**for THE DEVELOPMENT PERMIT BOARD
January 27, 2025**

**Heather Lands Parcel F - 689 W 35th Ave
DP-2024-00853 – CD-1 (pending)**

Figure 5: Building Heights and Massing Comparison between Rezoning (left) and DP (right)

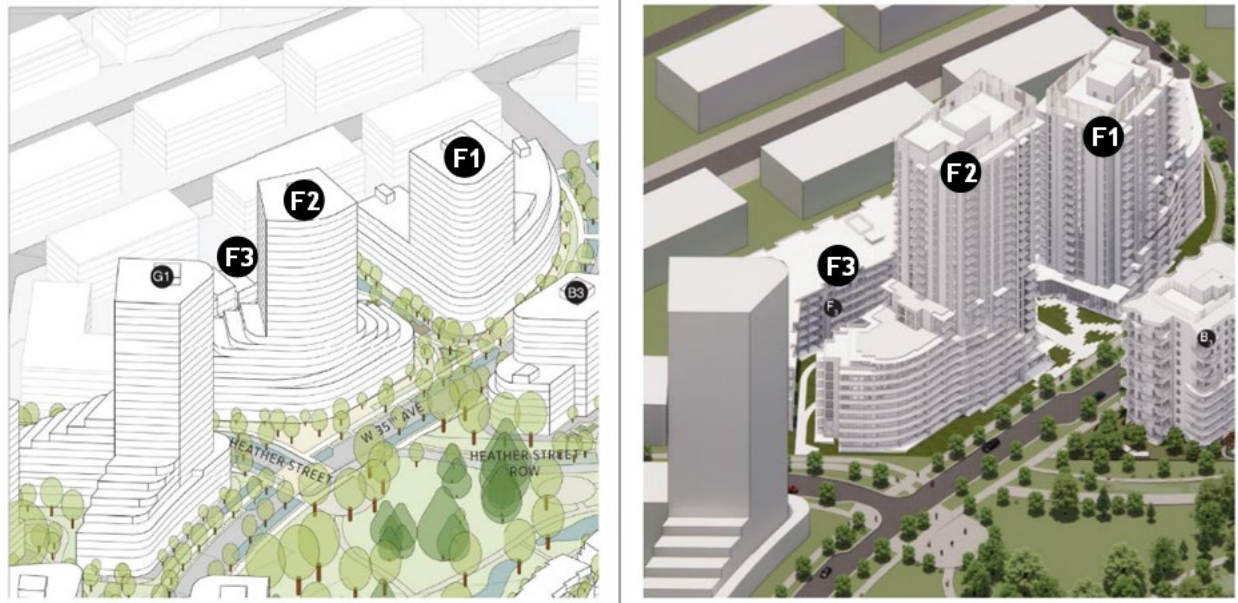
a) Increase in podium heights and massing

The Guidelines envision 6-storey podium for building F1 and a terraced podium from 4 to 10 storeys for building F2 with setbacks above level 4 or 5 for a continuous street wall expression on W 35th Ave and Heather Street.

Staff is supportive of a simpler building form by minimizing terraces and shoulder setbacks to achieve more efficient and sustainable buildings. However, the proposed podiums, at 8 storeys or more, create an overbearing presence in the public realm and do not comply with the intent of the Guidelines. Reduced podium heights to a maximum of 6 storeys are recommended. Refer to Recommended condition 1.1.

b) Increase in tower floorplates

The Guidelines anticipate slender and compact tower form with a tower floor plate of no more than 604 sq.m (6,500 sq.ft) (except G1 and F2 to accommodate terrace form) to ensure greater openness to the sky and solar access to the park and open spaces.

Staff is supportive of the proposed floorplate of the F2 tower, as F2 is treated as a signature building on the site, and its height and surrounding open spaces can proportionally support a larger tower massing. Tower F1, however, should generally align with the expectation of the guidelines to achieve a slender tower form that enhances sky views and solar access. Some flexibility to the floorplate can be considered to support Indigenous-led developments.

- 1.1 Design development to the proposed podium bulk and massing of buildings F1 and F2 to better align with the streetscape anticipated in the *Heather Lands Design Guidelines*;

Note to Applicant: Refer to *Heather Lands Design Guidelines* (Guidelines) Section 6.10.1 Building Typologies. This may be achieved by reducing the podium height to a maximum of six storeys. Compliance with this condition may impact achievable floor area, unit counts, and the locations of indoor amenity spaces.

- 1.2 Design development to provide a slender tower form for tower F1;

Note to Applicant: Refer to rezoning condition 1.1, Guidelines Section 6.10.1 Building Typologies, and *Citywide Development Guidelines Early Actions*. The intent of this condition is to improve solar access to the open spaces and mitigate the perceived bulkiness. This may be achieved by reducing the tower's width or its east-west diagonal dimension. A maximum floor plate area of 604 sq.m (6,500 sq.ft) ($\pm 10\%$) is recommended. Compliance with this condition may impact achievable floor area, unit counts, and the distribution of family units through the building.

Figure 7: Meeting Point Comparison between Rezoning (left) and DP (right)

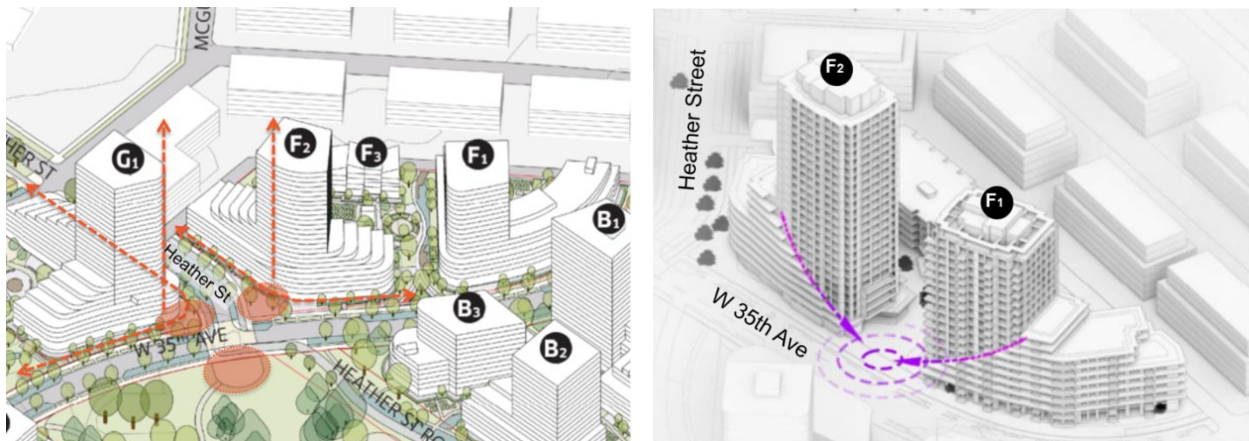
d) Change of the Meeting Point

The *Guidelines* envision that the Meeting Point is a welcoming gateway of Heather Lands, highlighting the Indigenous culture of “Welcome to All” and representing the coming together of the Nations. It is located at the intersection of W 35th Ave and Heather St - the highest point of the site - and is accentuated by two tall buildings F2 and G1, along with associated public open spaces, including two corner plazas and a plaza in the southern park (see *Figure 7*, left).

The Meeting Point is a significant place-making initiative outlined in the Guidelines. Staff recommend further exploration to enhance the characters of the Meeting Point, including the design of the ground floor and the open space framed at the corner to better reflect the intent of the Guidelines. Refer to Recommended condition 1.3.

- 1.3 Design development to building F2 to strengthen the characters of the Meeting Point;

Note to Applicant: Refer to rezoning condition 1.5, Guidelines Section 6.2 – Character. This condition may be achieved by:

- i. Introducing at-grade commercial use at the corner and providing an engaging frontage to enhance the public realm;
- ii. Updating the configuration of the intersection at W 35th Ave and Heather St to align with civil design and exploring publicly accessible open space from the curb to the building face at the corner. Also, refer to Standard Landscape condition A.1.22. and Standard Engineering condition A.2.10;
- iii. Reassessing the location of tower F2 to better emphasize the Meeting Point.
